MADRAS RECORD OFFICE.**Government of Madras.***Public Works* **DEPARTMENT.***P.W.D.*

G.O. No. 255.

No. 492. Read the following letter from the Chief Engineer for Irrigation, to the Secretary to Government, Public Works Department, dated Fort St. George, 9th January 1868, No. 18:—

I have the honor to submit a report on the condition of the works in progress at the Red Hill and Cholaveram Tanks, &c., (Madras Water Supply Project) which I lately inspected in company with the Superintending Engineer, Colonel Boileau.

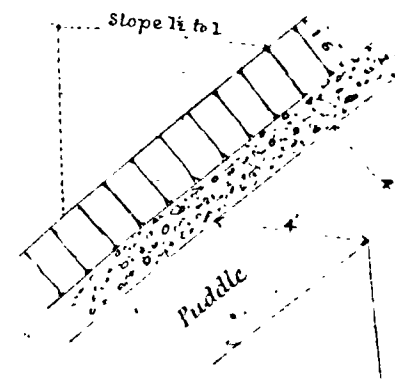
18
I would be the result
I would therefore propose to
finish in the first instance
up to a height suitable for a
water level, 5 feet above the
old Calingulah crest and to
raise the Calingulahs to that
level, the earthwork and re-
tirement being raised about
4 and 2 yards higher respectively.
During the next season, I
would raise the water surface
to 12 feet above the old Cal-
ingulah crest, build an ex-
tension of the new Calingulah
200 feet long to that level, and
raise the embankment to
the full height allowed for
in the design, at the same
time, closing the old Calin-
gulah altogether. The efficiency
of the works would thus be
gradually tested, and any

19
risk of accident removed.
There will be more or less settle-
ment of the earthen embank-
ments for several years
after they are thrown up, and
I would not advocate the raising
of the 200 feet Calingulah
above proposed to the full
supply level of 15 feet above
old Calingulah crest until
all signs of settlement shall
have disappeared. Experience
will then show if it can
with safety be raised to
that height, without throw-
ing greater strain on the
banks during high winds
than they are able to bear.
The estimate allows a height
of 6 feet above the full
supply level together with
a rough stone parapet 2
feet higher, but as there
